**NUMBER:** 09-010-15

Incorrect 5.7L Engine Oil Dipstick

This bulletin involves installing the correct engine oil indicator (Dipstick).

- 2014-2015 (WD) Dodge Durango
- 2014-2015 (WK) Jeep Grand Cherokee

**Fig. 1 Location Of The Part Number On The Dipstick**

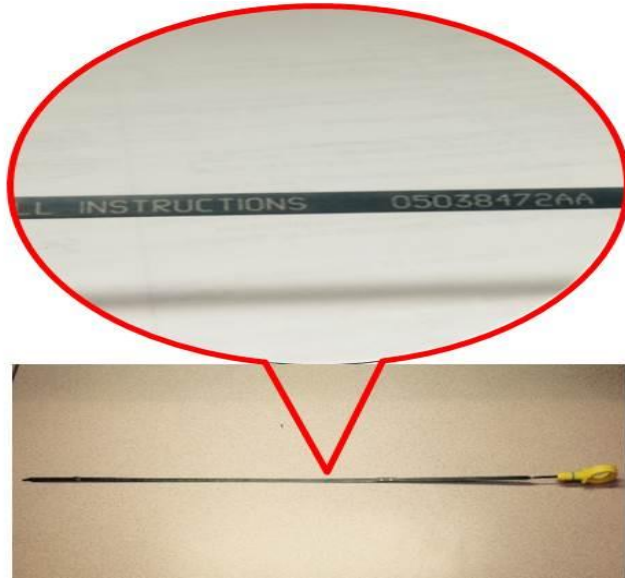
1. Remove the Dipstick from the tube and look for the part number.

- 
2. Is part number 53034186AD on the Dipstick?
    - a. Yes >>> This bulletin does not apply. Perform normal diagnostics.
    - b. No >>> Replace the Dipstick with part number 53034186AD.
  3. Verify and adjust oil level.
